ARCHITECTURAL COMMITTEE  
APPLICATION FOR EXTERIOR IMPROVEMENTS/CHANGES

NEIGHBORHOOD: Devonshire Place

ADDRESS: 6919 Chancery Place

SUBMITTAL SUBJECT: Removal of oak tree and landscape alterations per plan

3/14/2020  
 Lot 2  
 6919

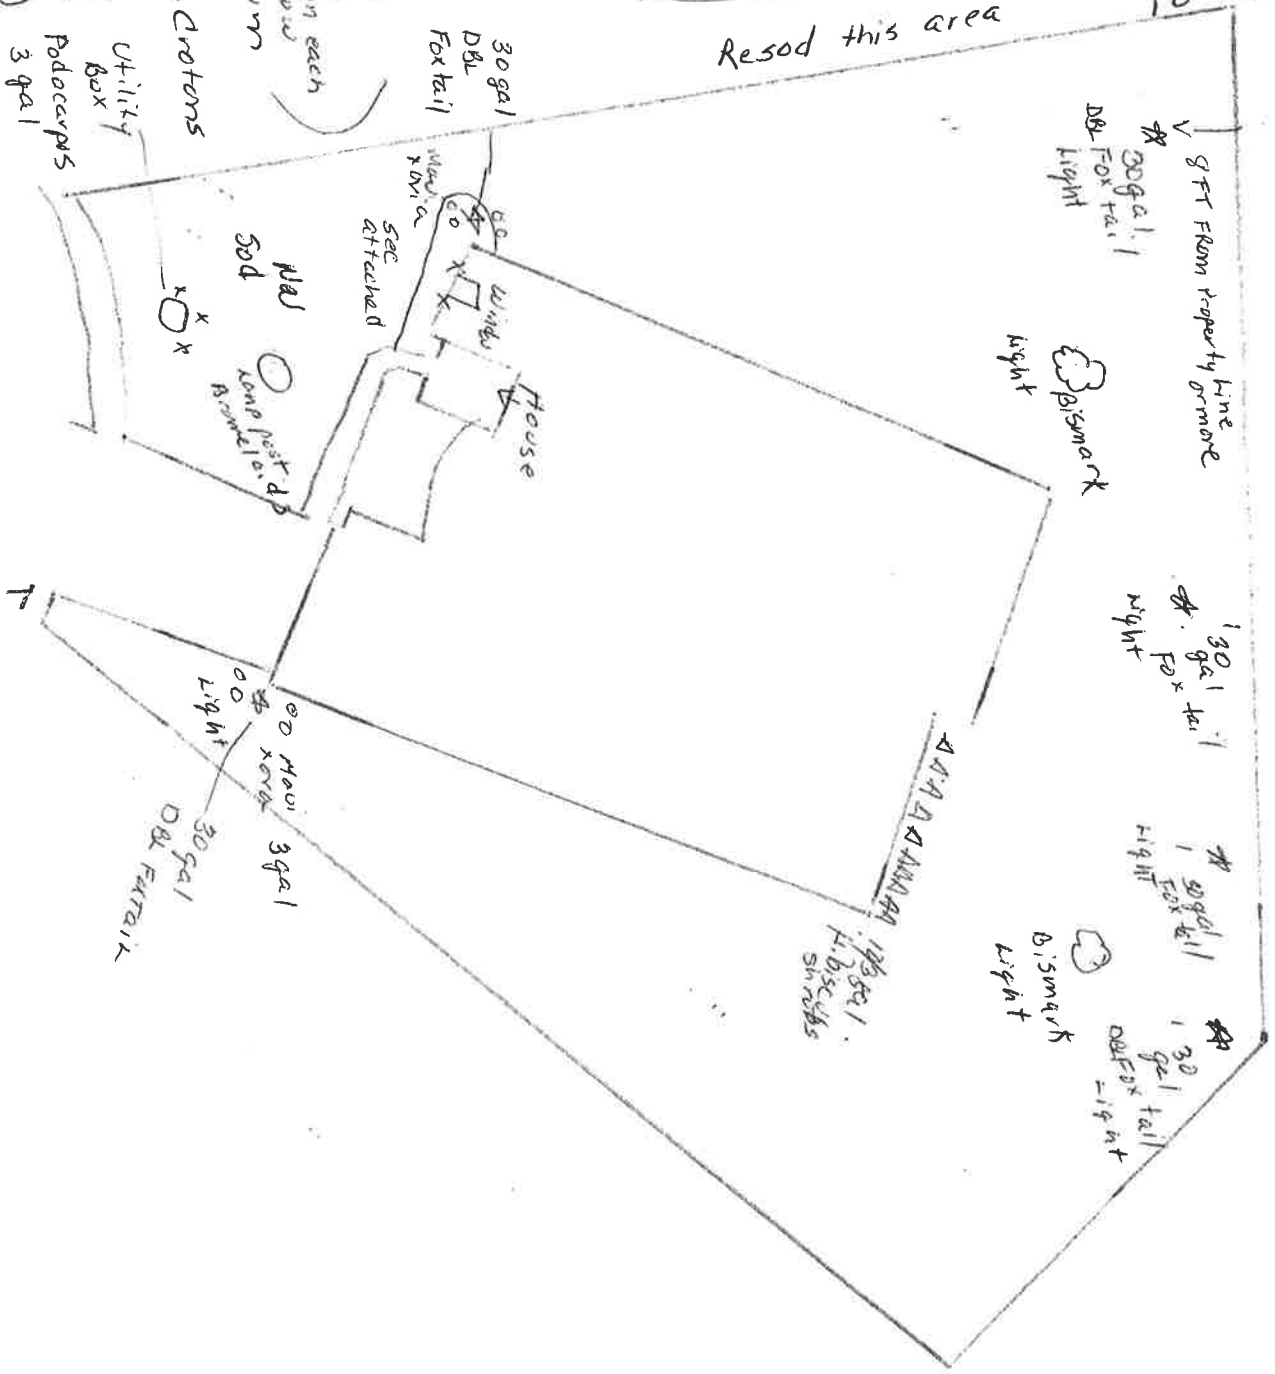
**Oak Removal approved-Please submit a more detailed and location-specific plan for the new landscaping**
